## IMMA contribution to 11/RESS

Issue raised by Japan on L5,L6,L7

R100 Section 8 K  
'vehicle fall-down test'

## Impact acceleration shock tests fall-down from stationary position.

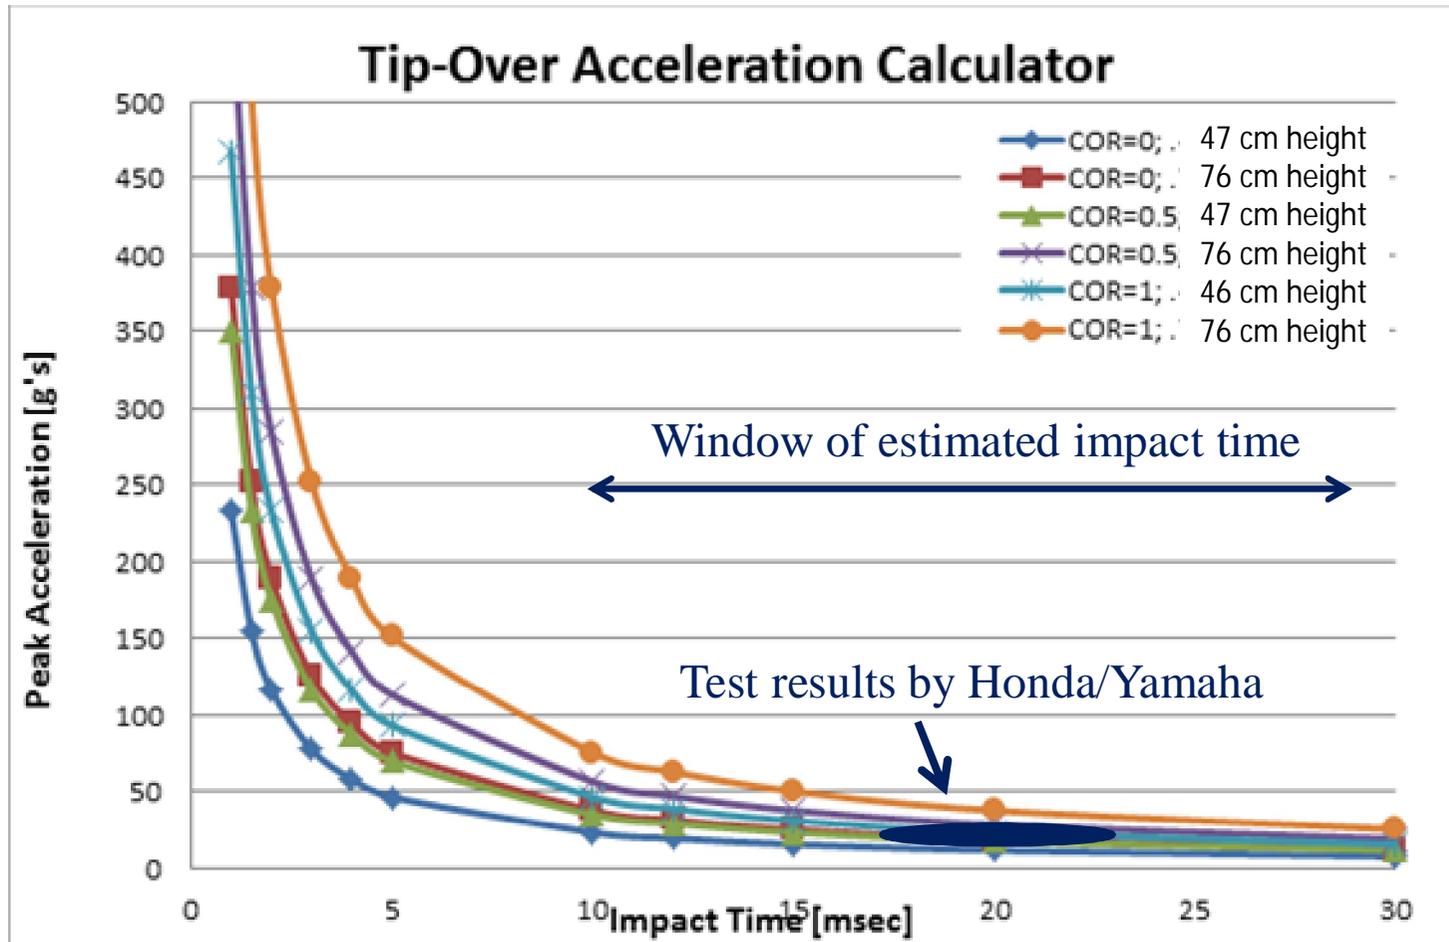
- Aim: to measure the ground contact impact time and measure the max impact acceleration shock 'g'.
- Yamaha vehicle: subjected to 8 repeated fall down tests. Measured values of g were below 25 gn (REESS weight 7 Kg)
- Honda vehicle: subjected to 4 repeated fall down tests. Measured values of g were below 20 gn (REESS weight 21 Kg)
  - Vehicle configuration/design has a strong impact on the point that hits the ground first and this will dampen the impact.
